X-TYPE

XT303-09

## TECHNICAL BULLETIN

### False Flagging Of DTC P0456 – No Evaporative Leak Present – Repair Procedure

ILLUSTRATION 1

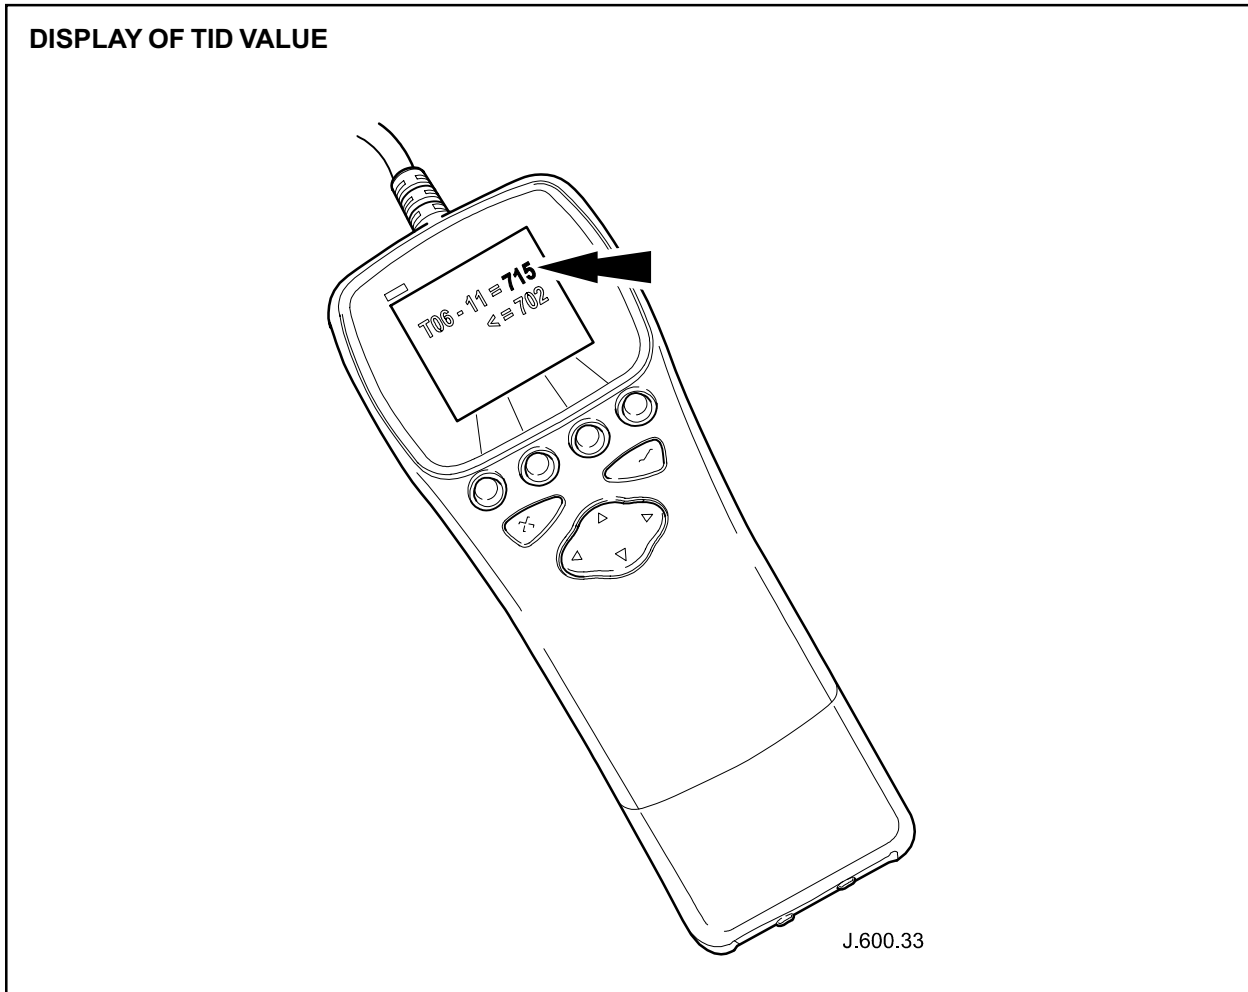
3. Navigate to 'select option' menu.
4. At 'select option' menu, highlight 'On-Board Monitoring Test Results' and press ✓.
5. Highlight 'Non-continuous' and press ✓.
6. Highlight 'TID 00 (11)' and press ✓.
7. Highlight 'T06 (1)' and press ✓.
8. TID value is now displayed (Illustration 1).

If no leak is present in the fuel tank, recalibrate the ECM as an existing module using the calibration on WDS disc issue 21. This will reduce the possibility of the problem occurring.
